From: Lyon, Fred
Sent: Monday, January 06, 2014 2:11 PM
To: johnsonc20@gmail.com
Cc: washpsr@gmail.com; Banic, Merrilee
Subject: 10 CFR 2.206 Pre-Meeting Call and Requested Letter (G20130776; MF3031)
Attachments: 10-4-13 EN letter to NRC re USACE Dam Analysis.pdf; cgs-seismic 2 206(v3).docx

Subject: **COLUMBIA GENERATING STATION, DOCKET NO. 50-397
ENERGY NORTHWEST'S REQUEST FOR NRC ASSISTANCE TO
OBTAIN INFORMATION FROM THE US ARMY CORPS OF ENGINEERS
(USACE) RELATED TO DAM FAILURE ANALYSIS**

Columbia Generating Station
Seismic Hazard Considerations
Determination of Immediate Safety Concerns
G20130776

Figure 1: SSE GROUND MOTION RESPONSE SPECTRUM

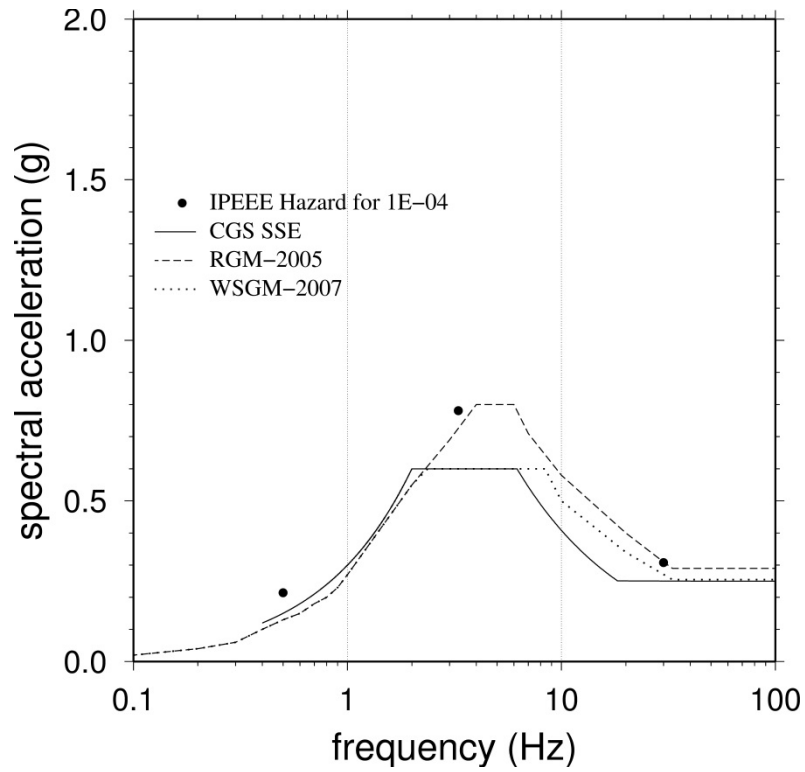
- The seismic design for the Columbia Generating Station (CGS) plant is represented by the SSE ground motion response spectrum, as shown in Figure 1 below (solid curve).

- The CGS SSE spectrum is anchored at an acceleration level of 0.25 g, but is much higher (up to 0.6 g) over the important frequency range of 2 to 10 Hz where plant structures and systems are most sensitive to earthquake ground motions.

- The licensee evaluated the impact on the CGS plant from potential seismic ground motions from several regional seismic sources over a wide range of hazard levels (the 1/10,000 mean hazard levels are shown as circles in Figure 1 below).

- The most recent WTP seismic design spectra are shown below as the dashed (2005) and dotted (2007) curves.
 - The most recent seismic hazard evaluation for the design of the WTP in 2007 is very similar to the CGS seismic design or SSE.

- In its letter to the Chairman dated October 31, 2013, the Oregon and Washington Physicians for Social Responsibility (OWPSR) mistakenly compares the 3 to 5 Hz spectral acceleration level of 0.8g for the WTP 2005 seismic design with the CGS SSE 20 Hz and greater spectral acceleration value of 0.25g.

Conclusion:

Based on the information discussed above, the NRC staff concludes that there is no immediate safety concern at CGS; however, the NRC will review the seismic hazard and risk evaluations conducted by Energy Northwest for potential regulatory action as part of its evaluation for NTTF R2.1.
